INTERIM AMENDMENT

FEDERAL SPECIFICATION

PULLER KIT, MECHANICAL

The General Services Administration has authorized the use of this interim amendment as a valid exception to Federal Specification GGG-P-643A, dated July 17, 1968.

FIGURE 51. Pulling adapter plates for use with type III puller kit.

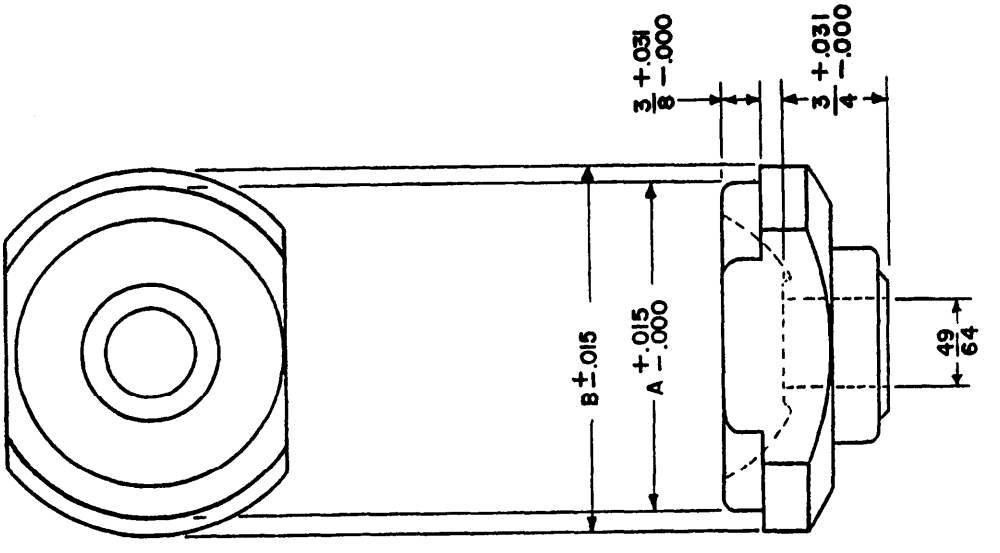
Figure 51. Delete present figure and substitute the following figure:
